MODEL BD-100-1A10 (CL-300)

REWORK – WING TANK – ADDITION OF SEALANT TO FACILITATE WATER DRAINAGE FROM WING FUEL TANKS AND PREVENT ERRATIC FUEL INDICATIONS

SERVICE BULLETIN

**REWORK – WING TANK – ADDITION OF SEALANT TO FACILITATE
WATER DRAINAGE FROM WING FUEL TANKS AND
PREVENT ERRATIC FUEL INDICATIONS**

K1000070228 – Kit – Fuel Tank Thermal Sealant Rework BL 0.00
(Sheet 2 of 3, Rev. A)

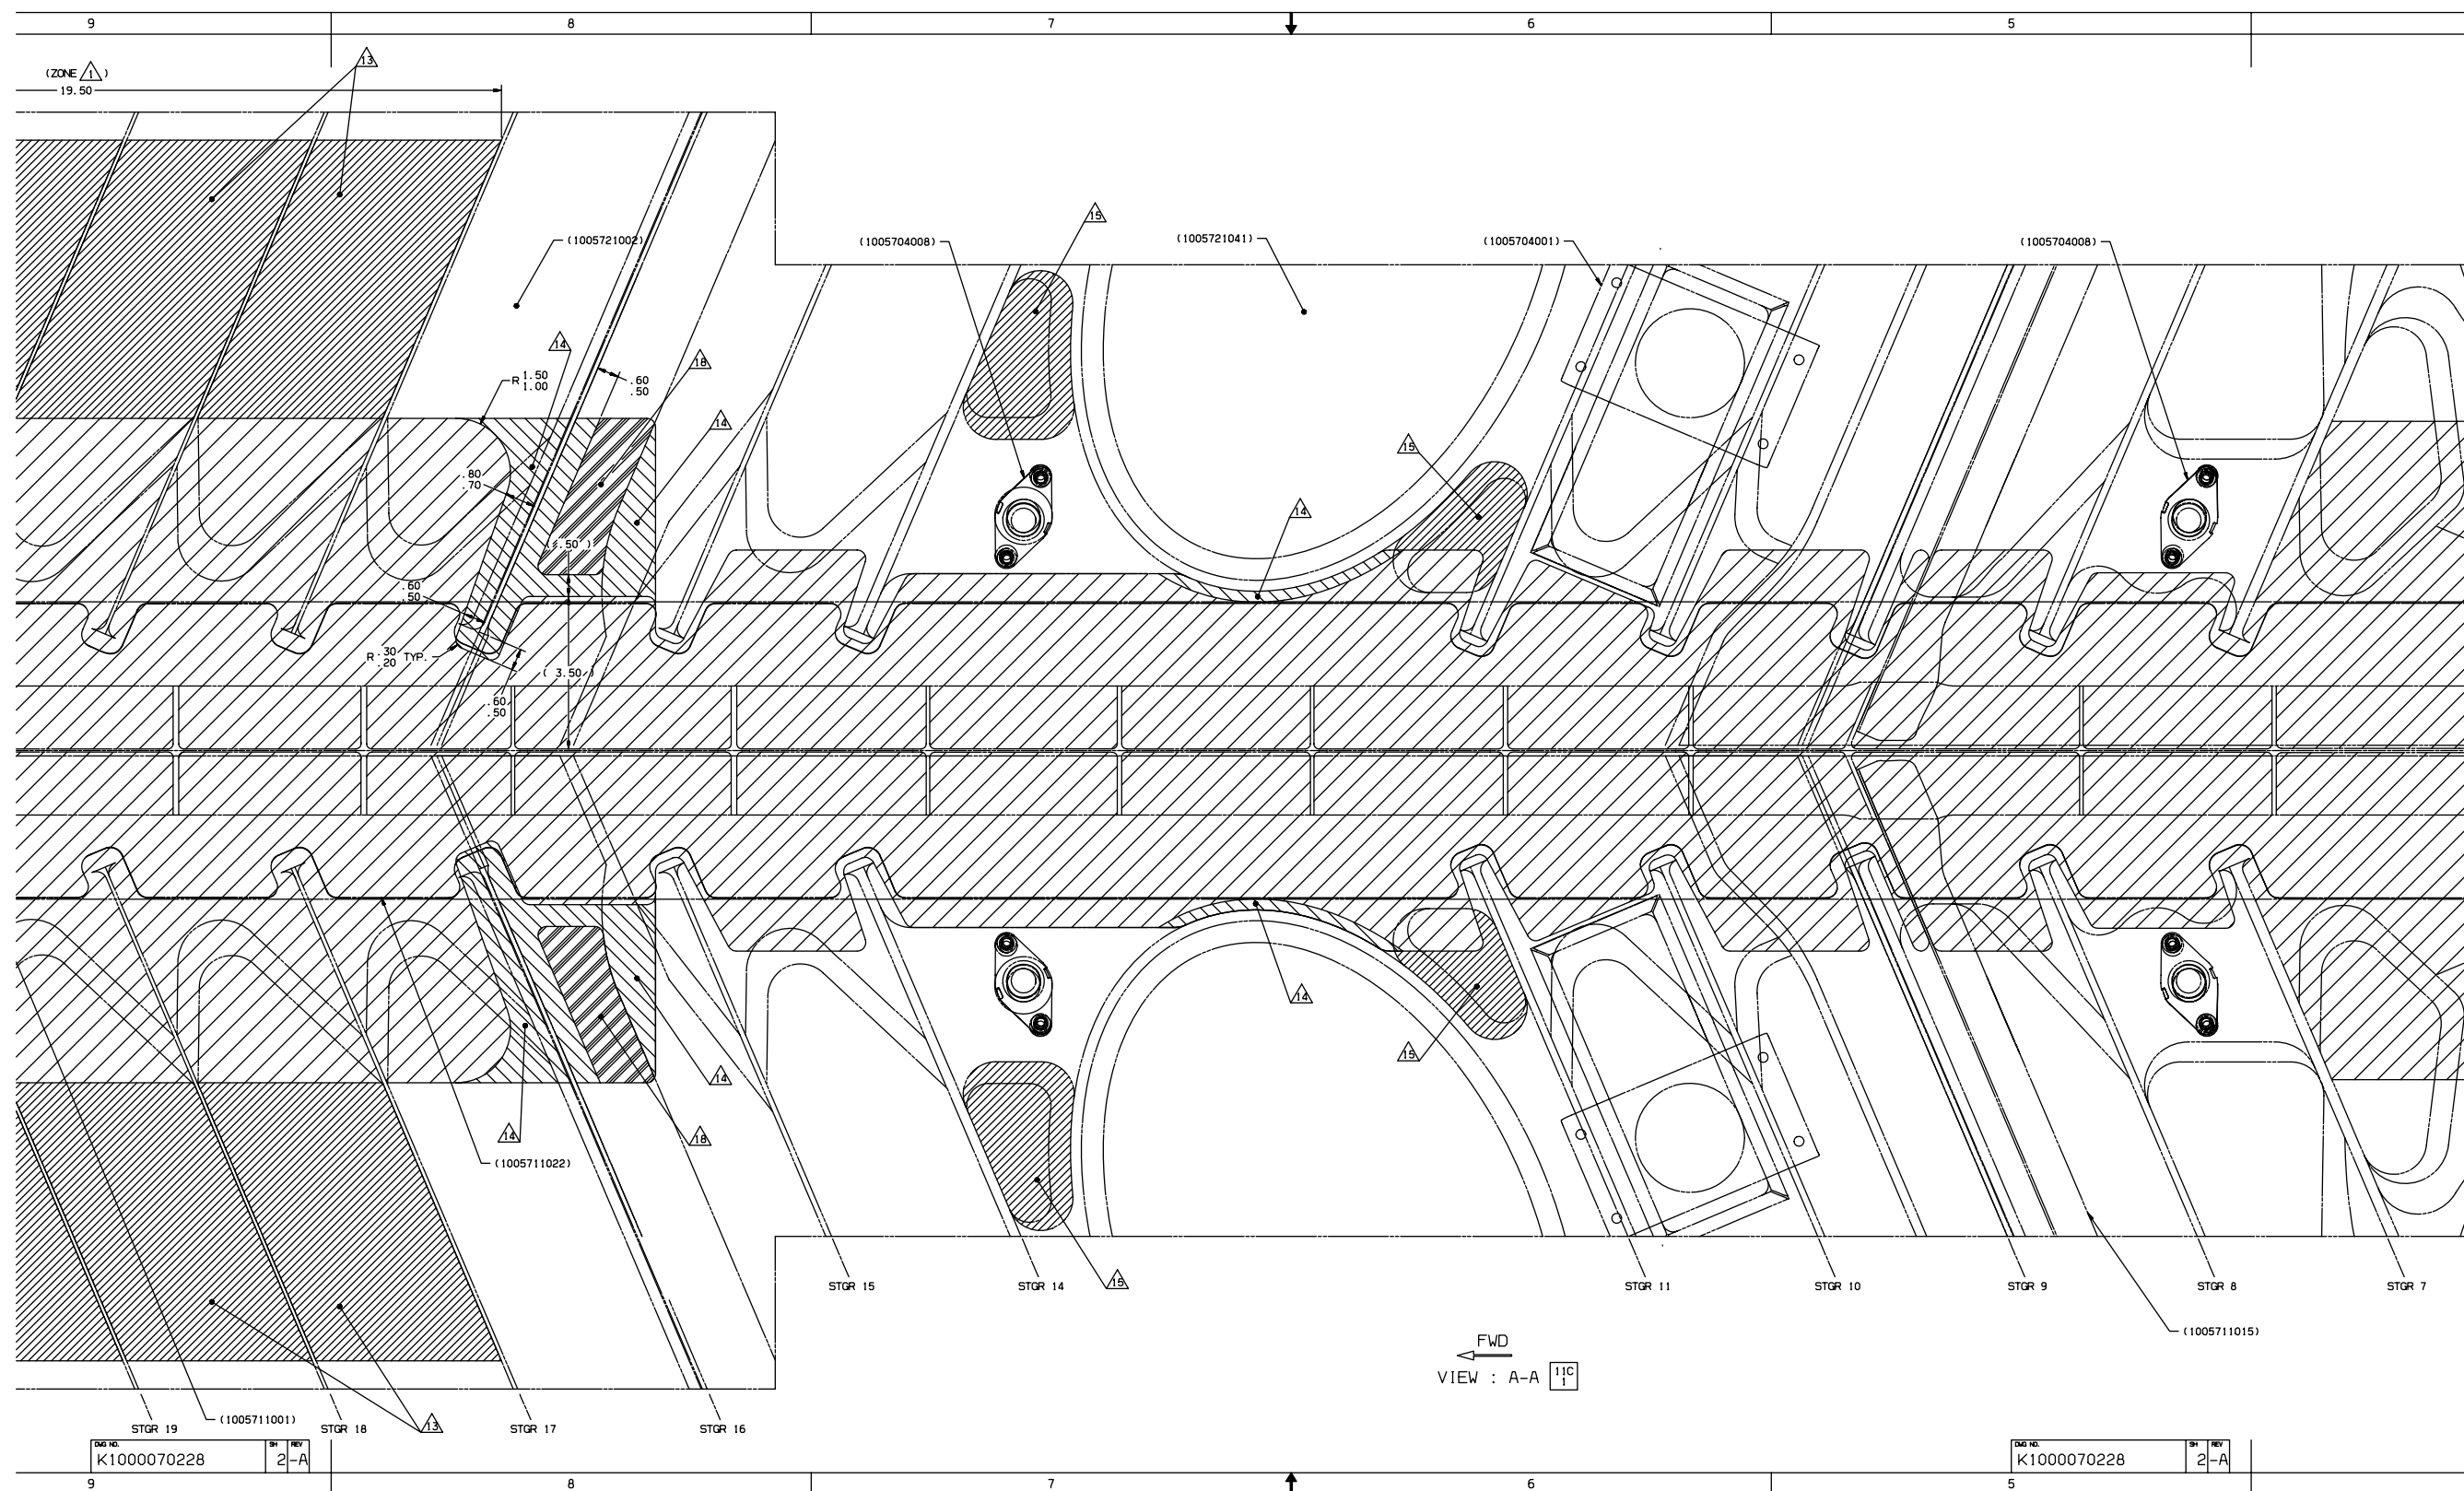
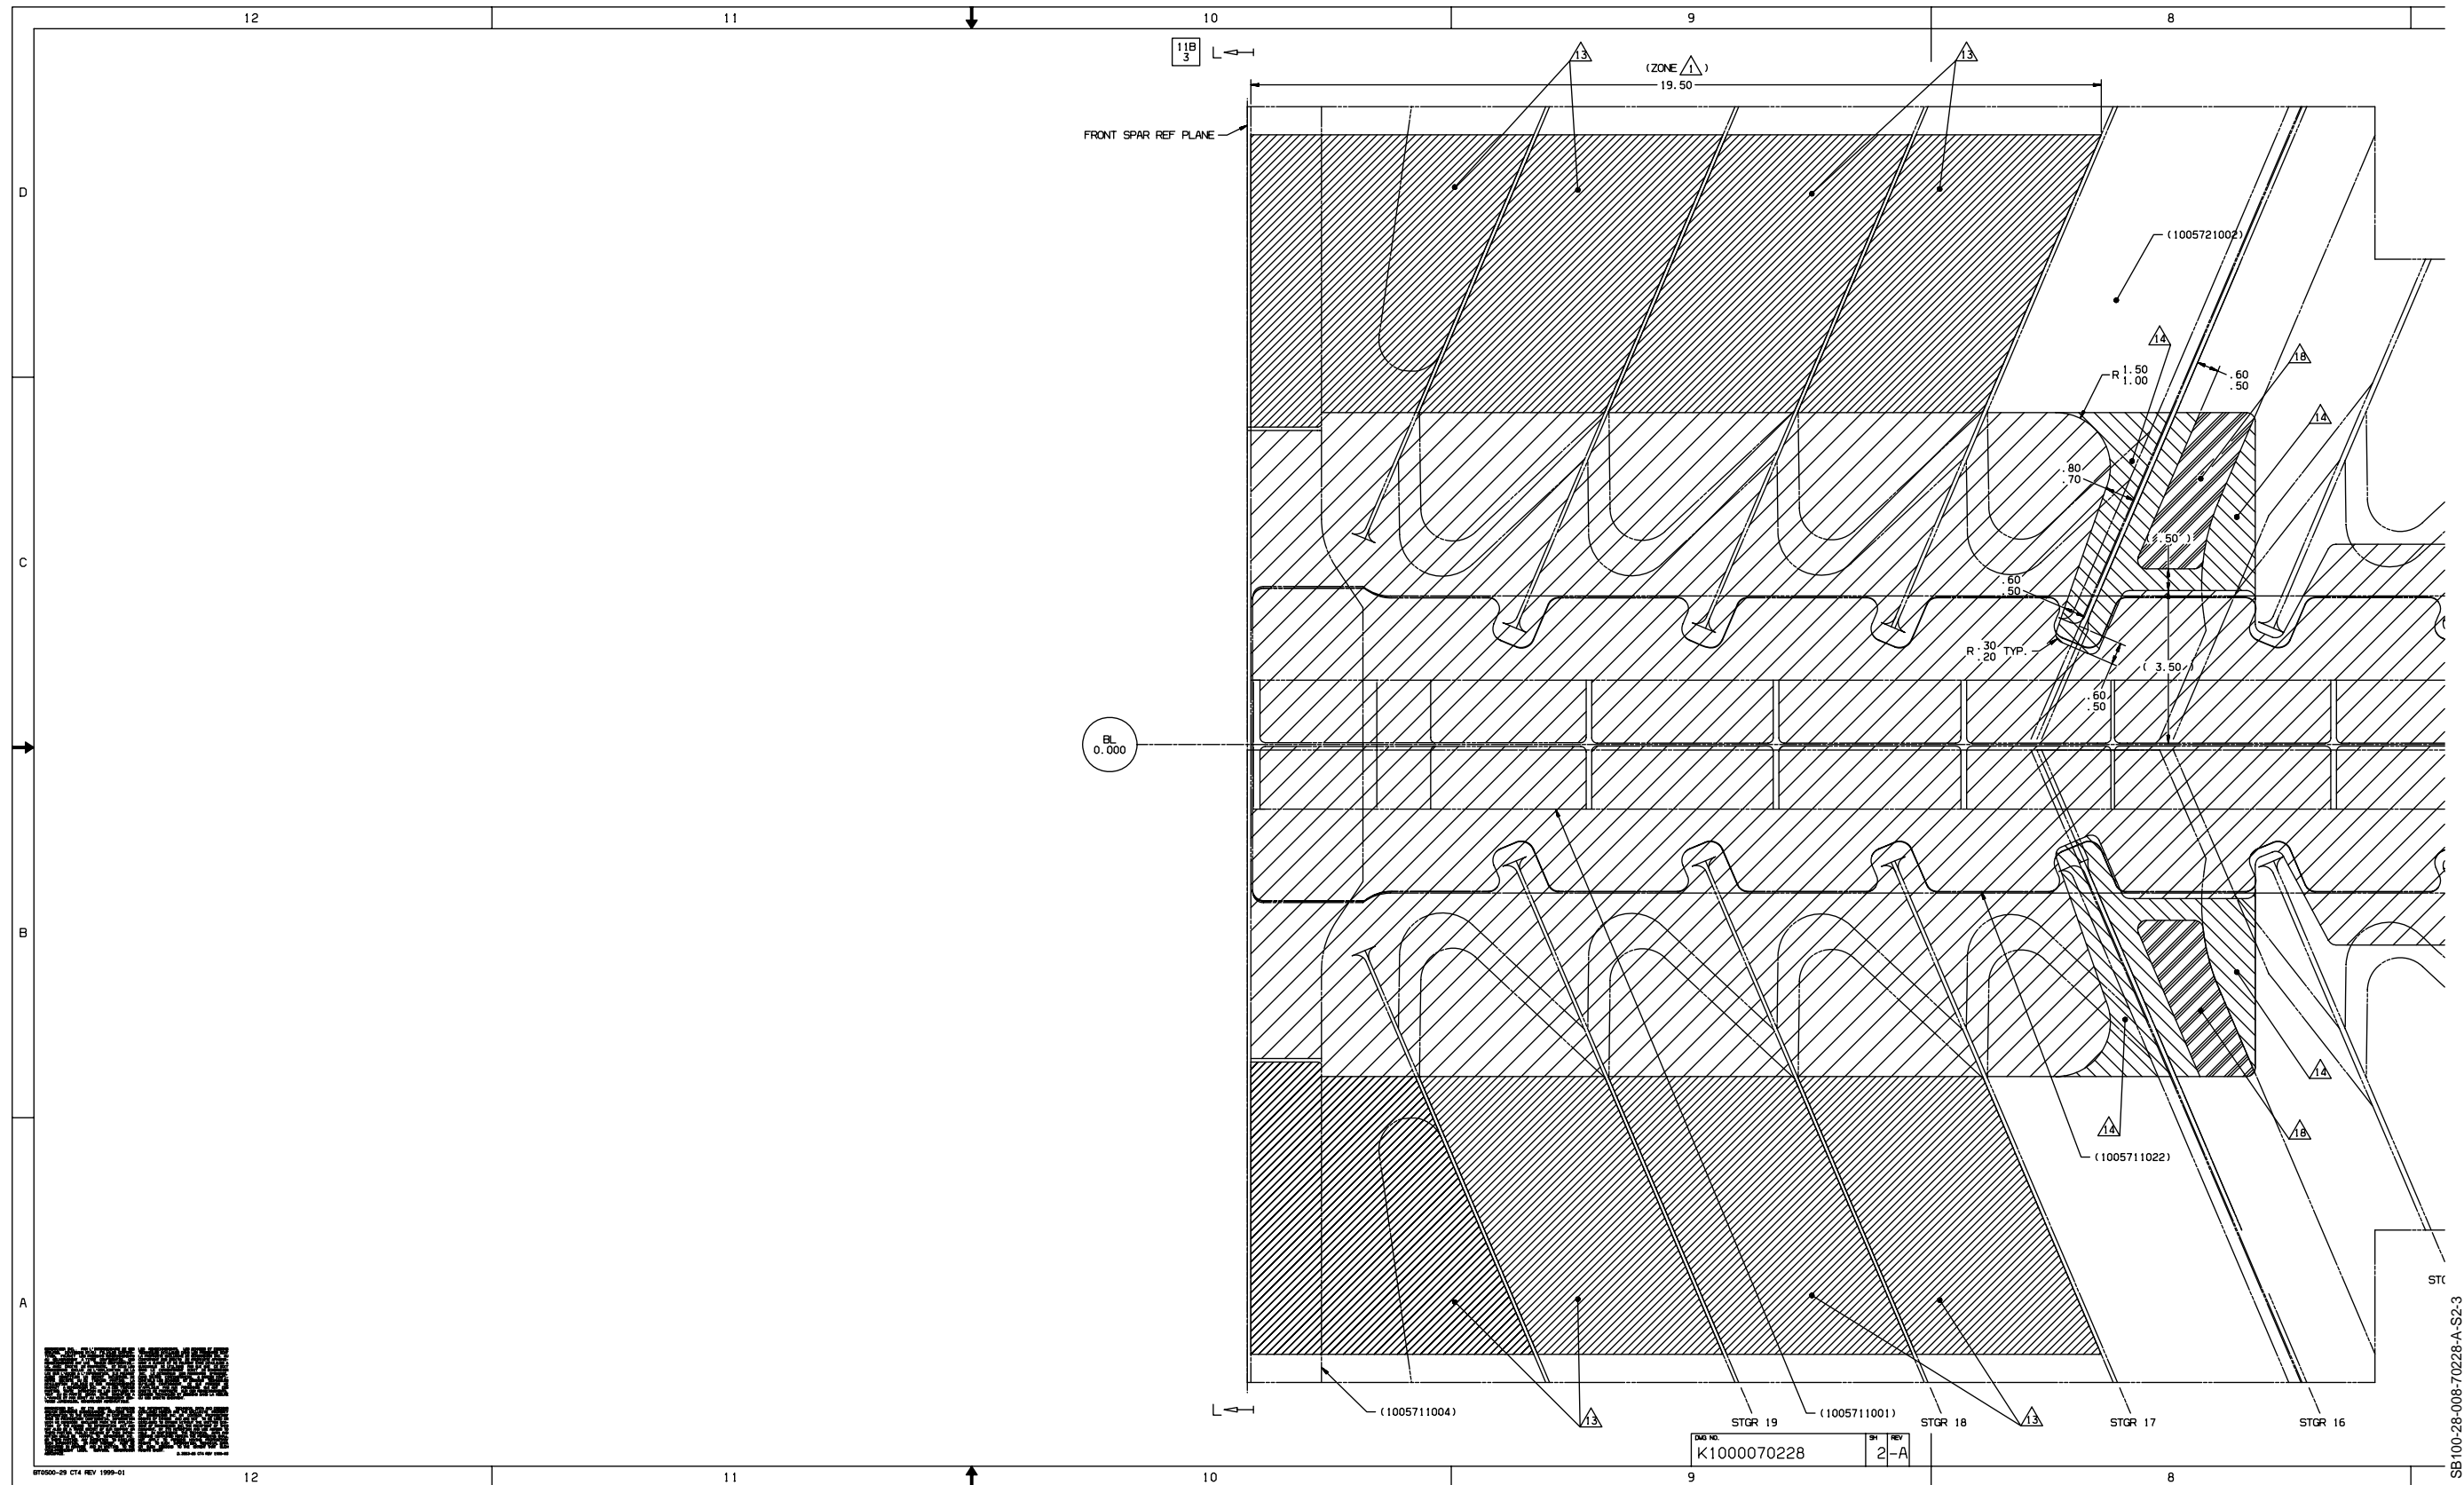
- (4) Verify the thickness of the sealant in the area indicated by flag note 16. The sealant should be at 0.75 to 0.85 inch (19.05 to 21.59 mm) from the top of the stringer. Refer to Kit Drawing K1000070228; section P-P.
 - (a) If the sealant thickness is greater than 0.85 inch (21.59 mm), remove excess sealant using non-metallic tools or Scotch-brite and prepare surface as per Paragraph 2.B.(3). Refer to Kit Drawing K1000070228.
 - (b) If the sealant thickness is less than 0.75 inch (19.05 mm), prepare surface as per Paragraph 2.B.(3). Refer to Kit Drawing K1000070228.
- (5) Inspect the reworked areas for damage to structure or finish before the application of new sealant. If any damage is present, contact Bombardier Aerospace Customer Support Engineering for disposition.
- (6) Inspect the reworked area sealant for damage and good adhesion to structure.

NOTE: Minimum sealant thickness over fasteners is required to meet EMC/Lightning requirements.
- (8) Install thermal insulation sealant, Part No. PR-1429 B-1/2 or PR-1429 B-2 (BAMS 552-006) as per TASK 51-23-00-390-807, in the areas indicated by flag note 13 and 16 as required to provide a smooth and evenly sloped water drainage path. Refer to Kit Drawing K1000070228; view A-A, sections L-L, N-N, and P-P.
